Prepared by MAB	Aircraft Make / Model	Float / Ski Model 2100, 2350, 3000 & 3450 Amphibious Floats	Page 1 1
FAA Reviewed <input checked="" type="checkbox"/>	Title <b>Addition of Hydraulic Accumulator</b>

SERVICE LETTER #48

TITLE: Addition of Hydraulic Accumulator

TYPICAL INSTALLATION OF ACCUMULATOR HOSE – ALL MODELS

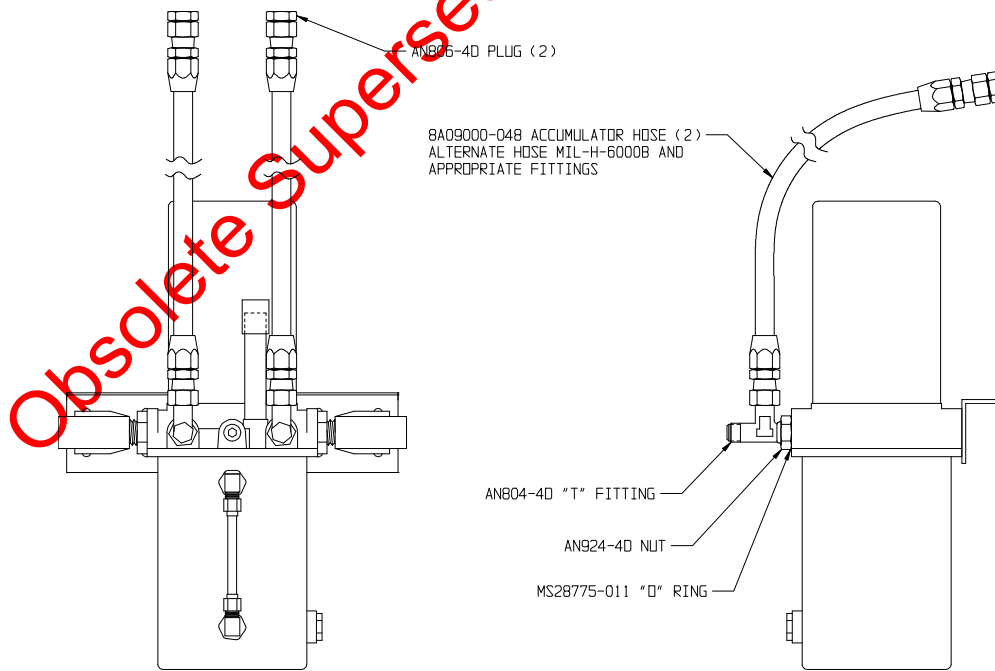
REASON: Aircraft experiencing "hydraulic lockup" (gear does not cycle up unless emergency gear selector handle is cycled) as evidenced by landing gear not retracting due to pressure buildup on back side of piston thereby not allowing opposite pressure switch to make contact.

METHOD OF COMPLIANCE: Add accumulators per Service Kit #32 and below illustrations.
